EASA	NOTIFICATION OF A PROPOSAL TO ISSUE AN AIRWORTHINESS DIRECTIVE
	<p>PAD No.: 10-122</p> <p>Date: 15 December 2010</p> <p>Note: This Proposed Airworthiness Directive (PAD) is issued by EASA, acting in accordance with Regulation (EC) No 216/2008 on behalf of the European Community, its Member States and of the European third countries that participate in the activities of EASA under Article 66 of that Regulation.</p>
In accordance with the EASA Continuing Airworthiness Procedures, the Executive Director is proposing the issuance / cancellation of an EASA Airworthiness Directive (AD), applicable to the aeronautical product(s) identified below. All interested persons may send their comments, referencing the PAD Number above, to the e-mail address specified in the 'Remarks' section, prior to the consultation closing date indicated.	
Type Approval Holder's Name : AIRBUS	Type/Model designation(s) : A300, A310, A300-600 and A300-600ST aeroplanes

TCDS Number : France No.145 and EASA.A.014	
Foreign AD : Not applicable	
Supersedure : None	
ATA 29	Hydraulic Power – Hydraulic Accumulator – Inspection / Replacement / Placards Installation
Manufacturer(s):	Airbus (formerly Airbus Industrie)

Appendix 1

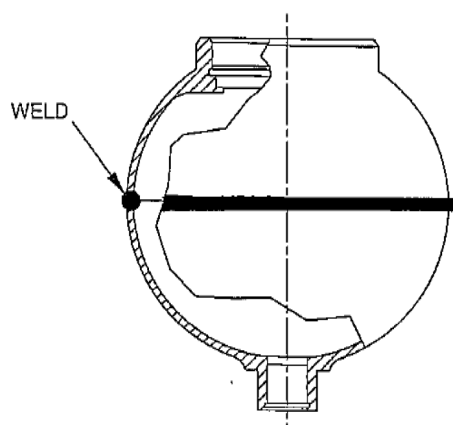
HYDRAULIC ACCUMULATOR : designed with 4 parts and 3 welds

OLD DESIGN

HYDRAULIC ACCUMULATOR : designed with 2 parts and 1 weld

NEW DESIGN

<p>(2) If, during the visual inspection as required by paragraph (1) of this AD, an old design hydraulic accumulator is found installed on any of the affected hydraulic circuits as indicated in Table 1 of this AD, as applicable to aeroplane model, replace each affected old design accumulator with a new design accumulator in accordance with the instructions of Airbus SB A300-29-0126 Revision 01, SB A310-29-2099, SB A300-29-6063, or SB A300-29-9012, as applicable to aeroplane model.</p> <p>(3) Irrespective of findings during the visual inspection as required by paragraph (1) of this AD, install placards at the designated locations of the affected hydraulic circuits indicated in Table 1 of this AD, as applicable to aeroplane model, in accordance with the instructions of Airbus SB A300-29-0127, SB A310-29-2100, SB A300-29-6064, or SB A300-29-9013, as applicable to aeroplane model.</p>	Affected Aeroplanes	Affected Hydraulic Circuit(s)	A300 PRE mod 02447	Blue and Green	A300 POST mod 2447	Blue	A300-600 and A300F4-608ST	Blue	A310	Green
Affected Aeroplanes	Affected Hydraulic Circuit(s)										
A300 PRE mod 02447	Blue and Green										
A300 POST mod 2447	Blue										
A300-600 and A300F4-608ST	Blue										
A310	Green										
Ref. Publications:	<p>Airbus SB A300-29-0126 Revision 01 and SB A300-29-0127 original issue.</p> <p>Airbus SB A310-29-2099 and SB A310-29-2100, both original issue.</p> <p>Airbus SB A300-29-6063 and SB A300-29-6064, both original issue.</p> <p>Airbus SB A300-29-9012 and SB A300-29-9013, both original issue.</p> <p>The use of later approved revisions of these documents is acceptable for compliance with the requirements of this AD.</p>										
Remarks :	<p>1. This Proposed AD will be closed for consultation on 12 January 2011.</p> <p>2. Enquiries regarding this PAD should be referred to the Airworthiness Directives, Safety Management & Research Section, Certification Directorate, EASA. E-mail ADs@easa.europa.eu.</p> <p>3. For any question concerning the technical content of the requirements in this PAD, please contact: AIRBUS SAS – EAW (Airworthiness</p>
